Rosefield Solar Farm (EN010158)

**Rosefield Solar Farm – Buckinghamshire Council's
comments on the Applicant's Response to the
Examining Authority's First Written Questions**

Buckinghamshire Council

May 2026

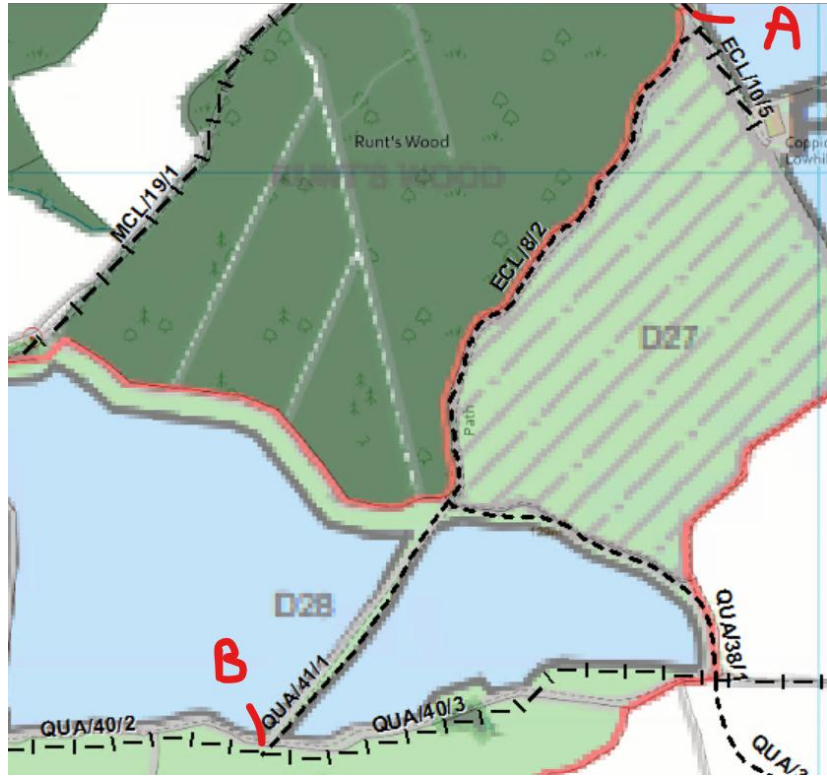
Q1.18.7	Worst case scenario Table 12.4 of ES Chapter 12 [APP-055] does not specify the maximum area of the Battery Energy Storage System (BESS) and Satellite Collector Compounds assessed as being a reasonable worst-case scenario. Confirm the maximum area assessed.	ES Volume 2, Chapter 12: Soil [EN010158/APP/6.2.2] Table 12.4 has been updated at Deadline 2 to include the maximum areas that have been assessed. The maximum area of the Battery Energy Storage System (BESS) is 7.8ha and Satellite Collector Compounds is 18.2ha; all areas are Grade 3b.	Buckinghamshire Council welcomes the breakdown of ALC grades for the BESS and Satellite Collector Compounds but points out that the formatting of the updated table is not displaying as intended and values have not lined up with the correct columns.
Q1.18.8	Outline Soil Management Plan (oSMP) – Department for Environment, Food & Rural Affairs (Defra) guidance	All soil handling and storage for the Proposed Development will be managed under the Defra guidance therefore the wording in paragraphs 3.2.9 and 3.7.7 has been updated in Outline SMP [EN010158/APP/7.7.3] at Deadline 2 for clarification.	The updates to the Outline SMP [EN010158/APP/7.7.3] at Deadline 2 have been noted.
